**ADDENDUM 2****Addendum #** 2**Date Issued** January 27, 2026**Project Name | Job #** White Earth Withdrawal Management Facility | 20237410**Bid Date | Time** Tuesday, February 3, 2026 | 3:00 pm

THIS ADDENDUM AMENDS AND BECOMES PART OF THE CONTRACT DOCUMENTS FOR EAPC PROJECT 20245580 DATED 12/5/2025, RESPECTIVELY. EACH BIDDER SHALL ACKNOWLEDGE RECEIPT OF THIS ADDENDUM BY MARKING THE ADDENDUM NUMBER AND DATE ON THE BID FORM.

A021

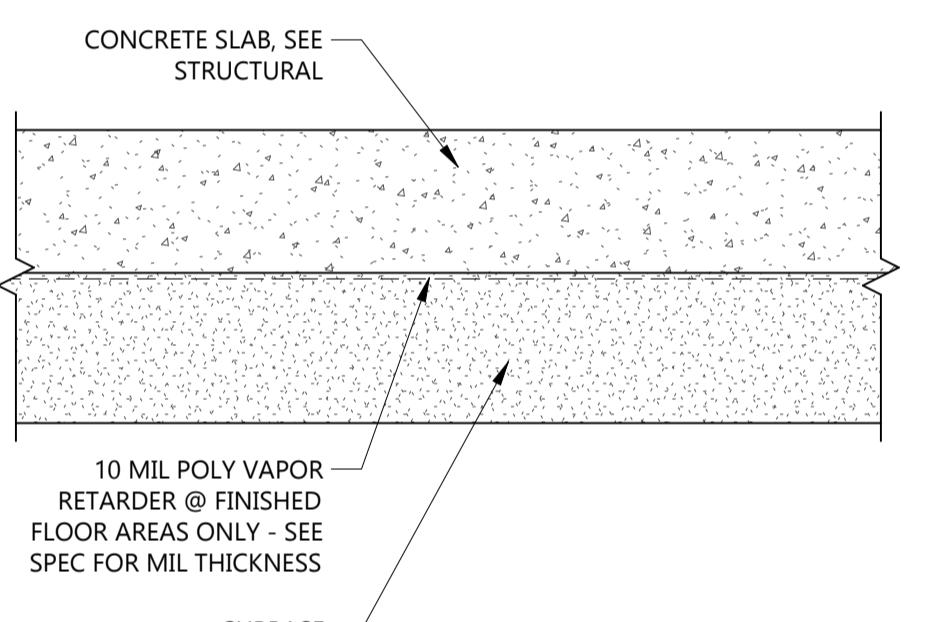
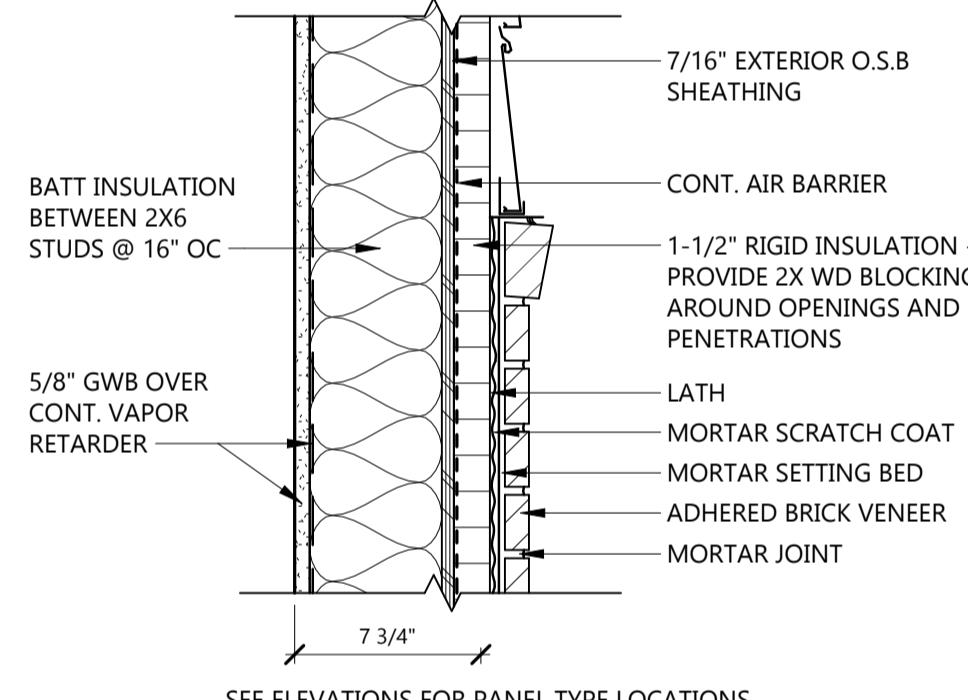
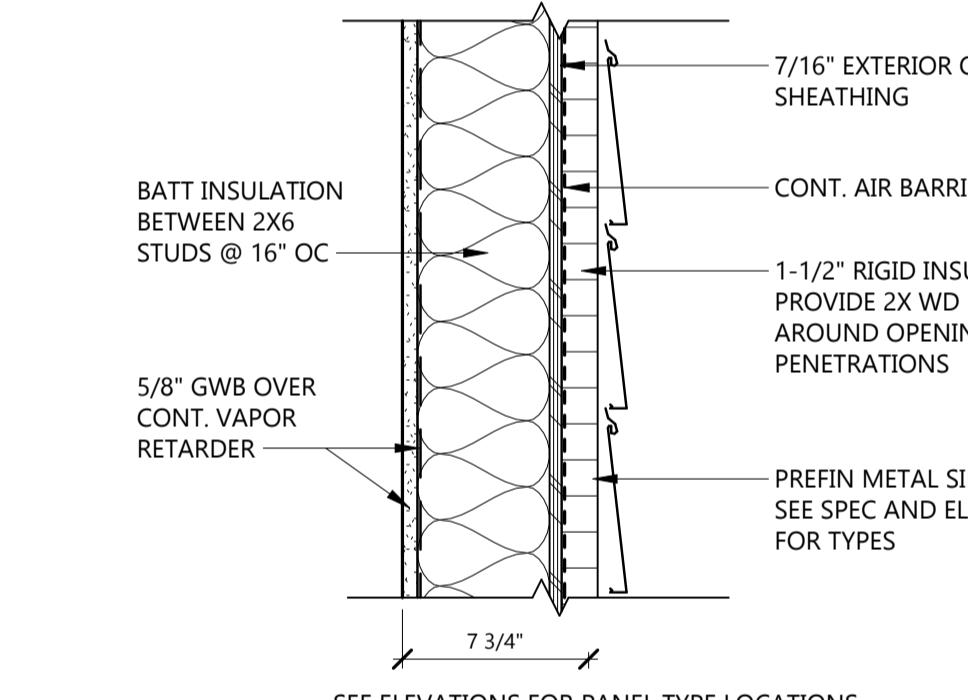
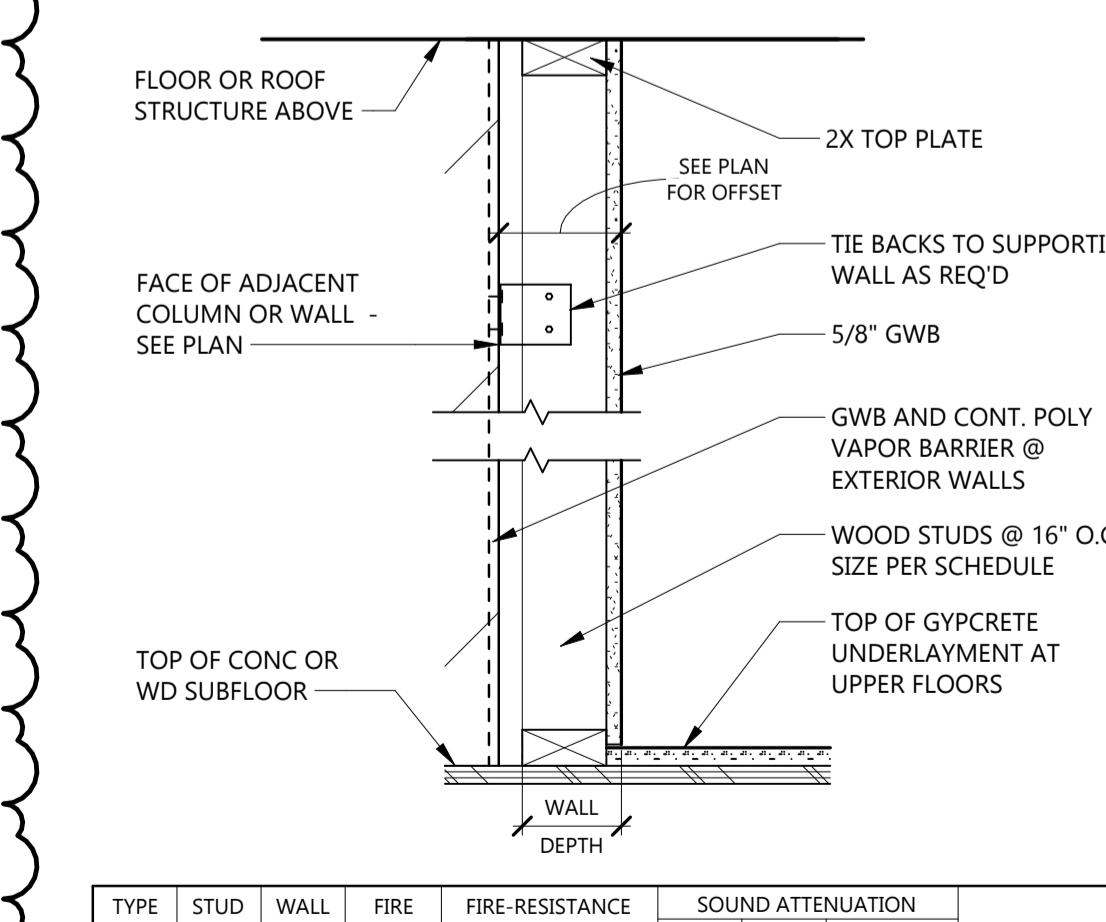
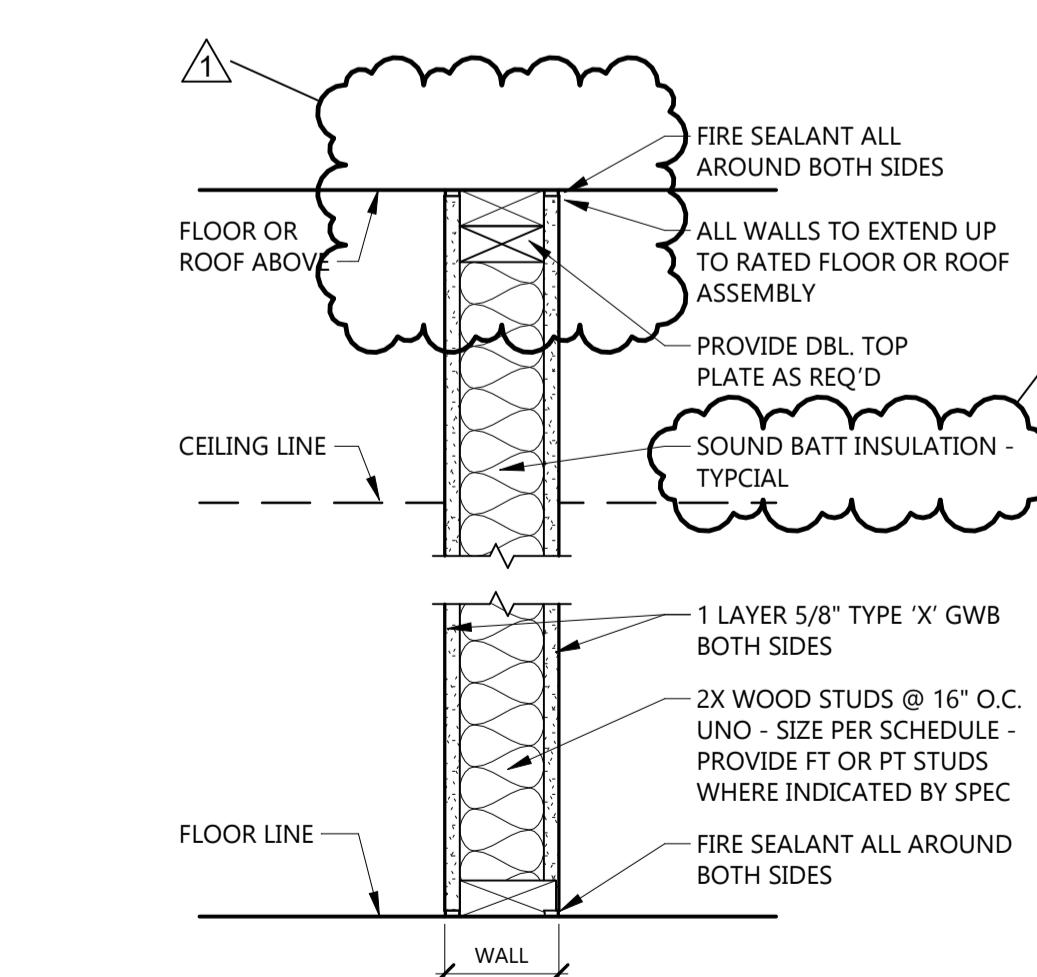
A021 ADD roof type "R2 – Alternate #04". Add ceiling type "C1". Remove top of wall detail callouts at wall types B and D. Modify D5 note on sound batt insulation.

A101

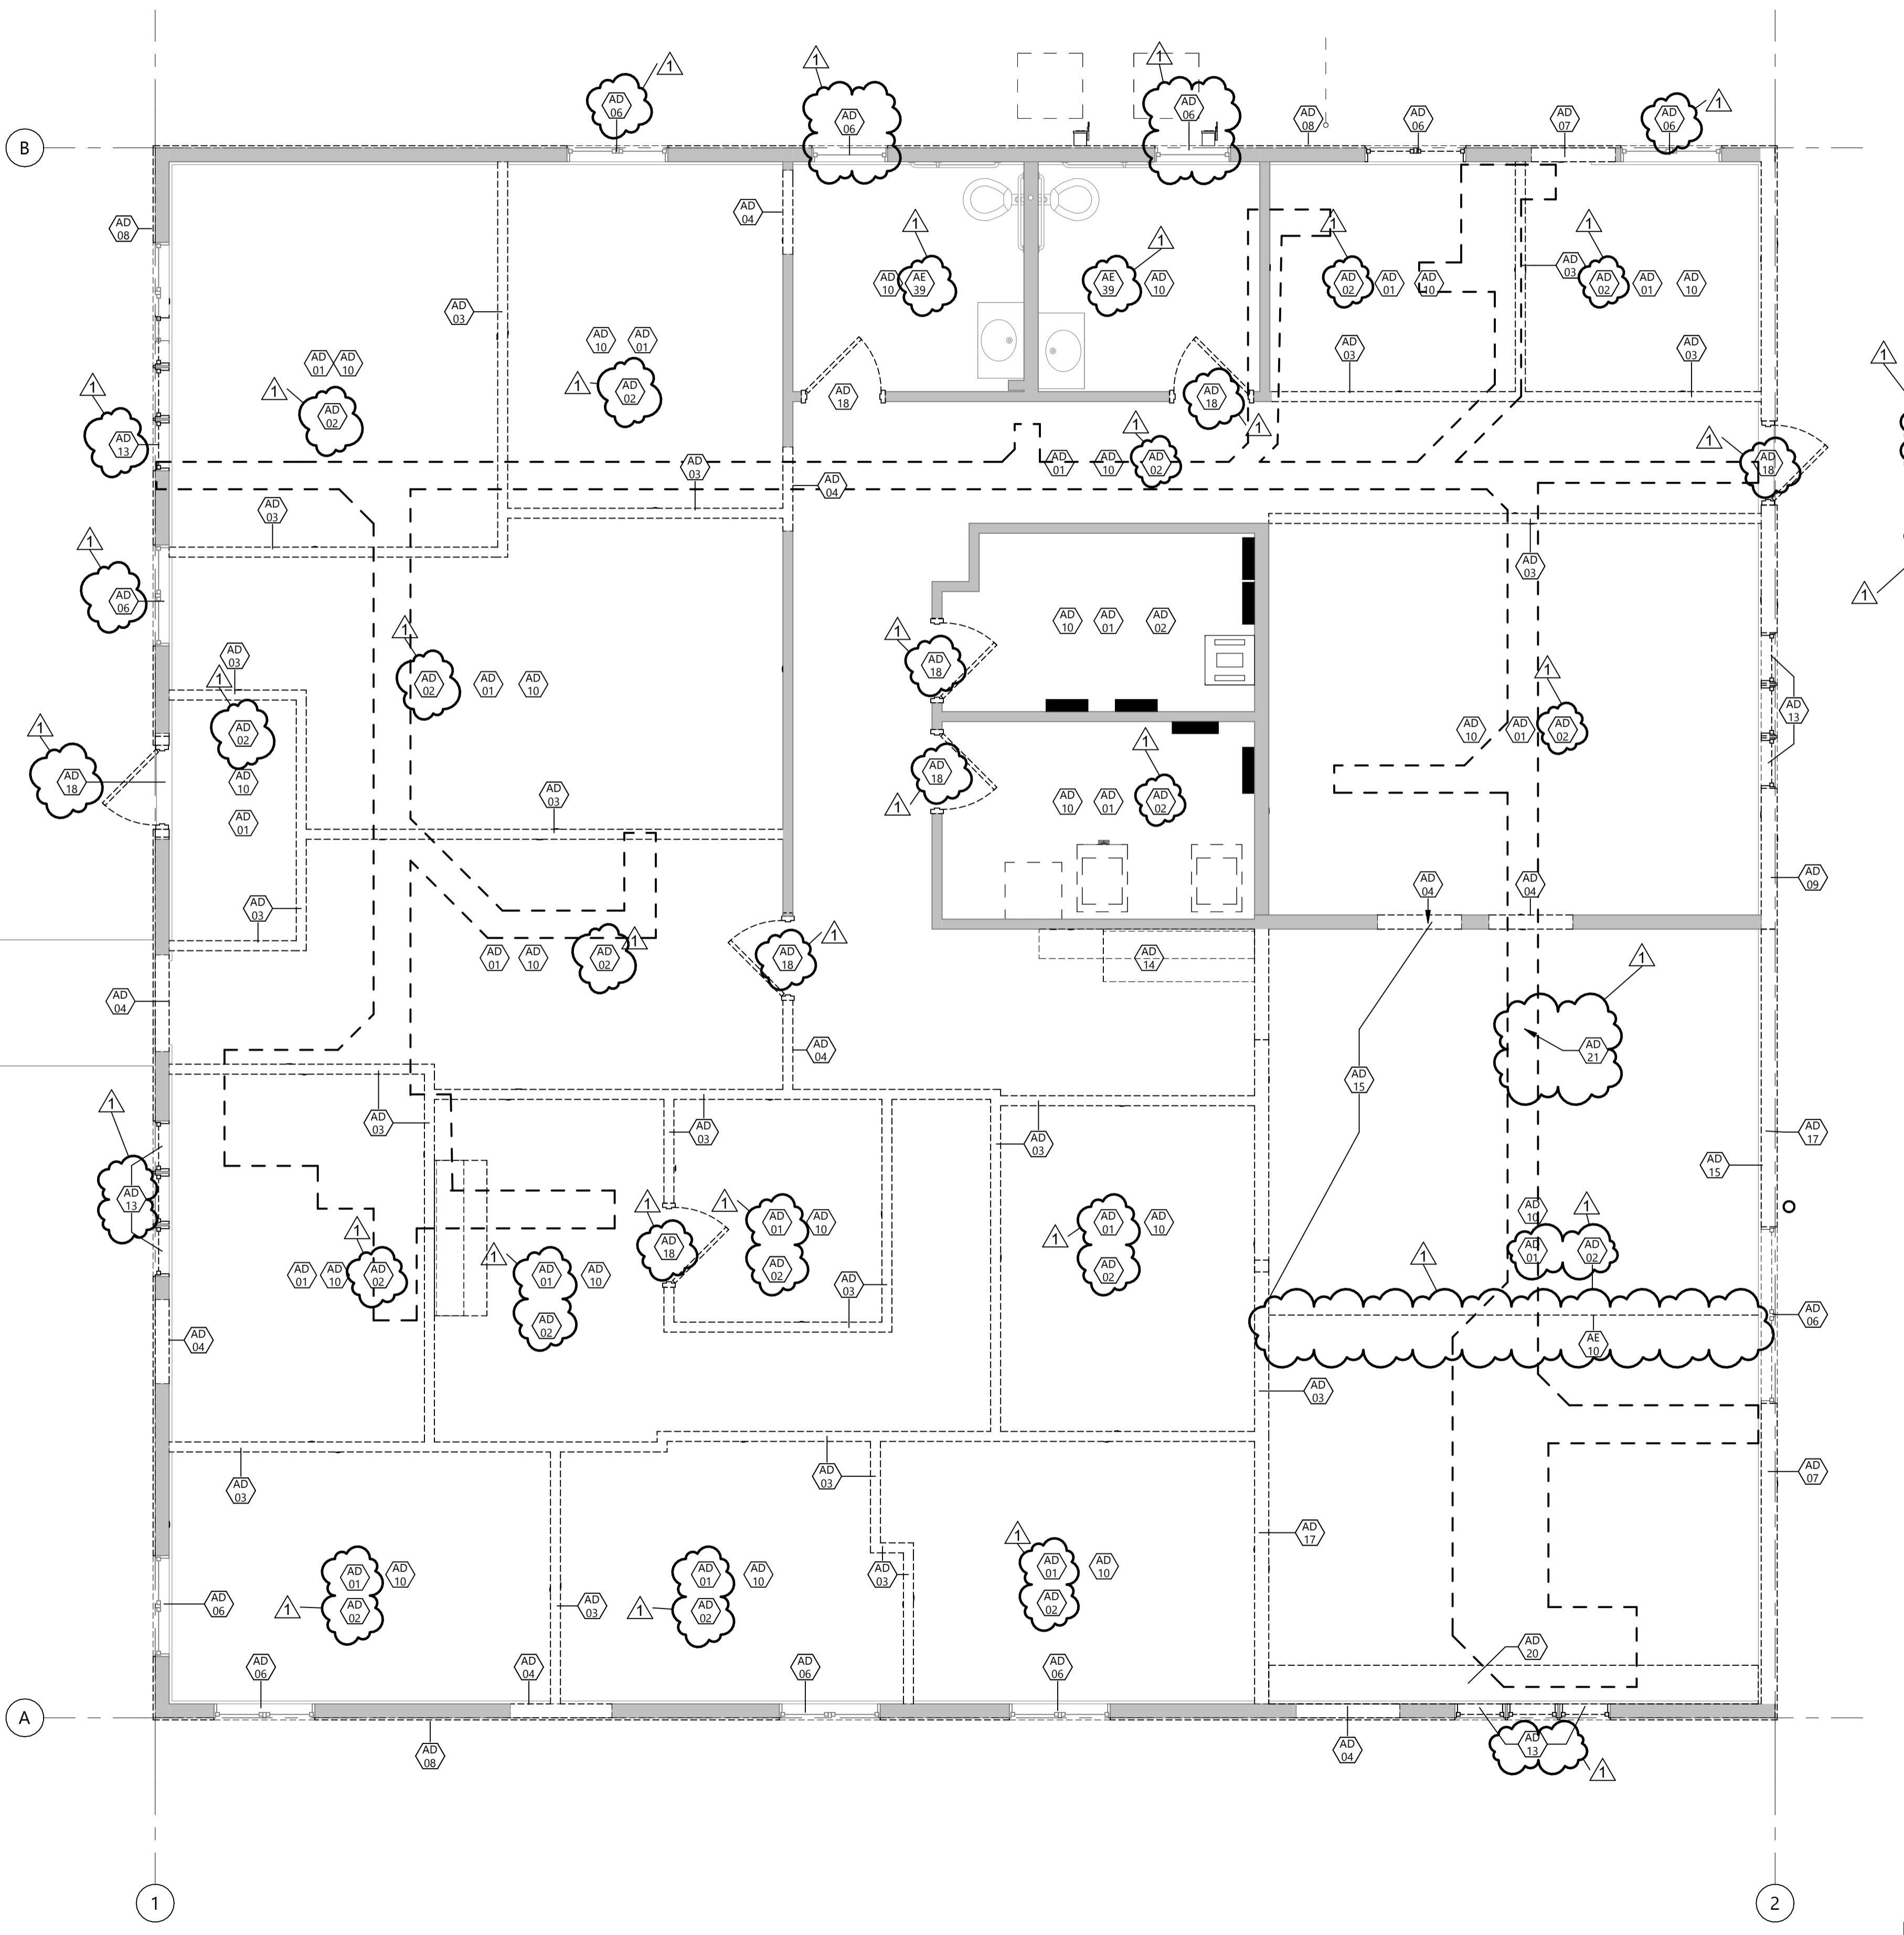
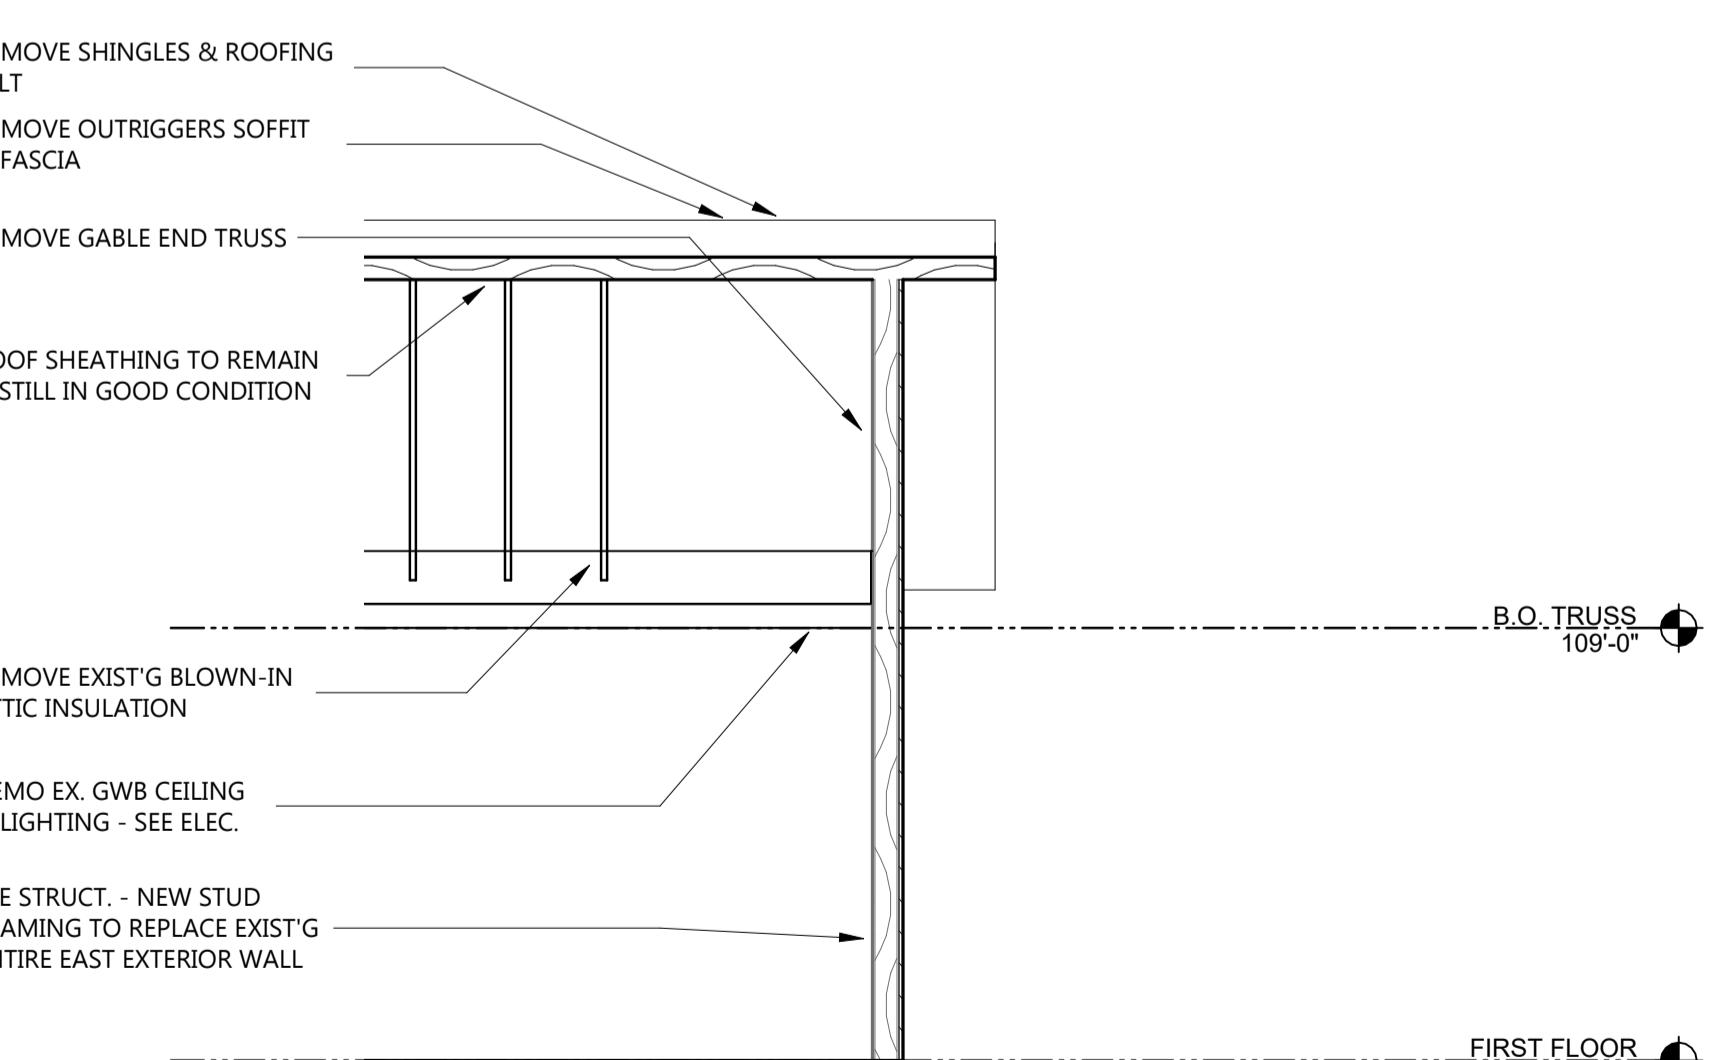
A101 Modify & add demo keynotes. Add general notes 24 & 25. Show concrete floor demo, see tag AD 21.
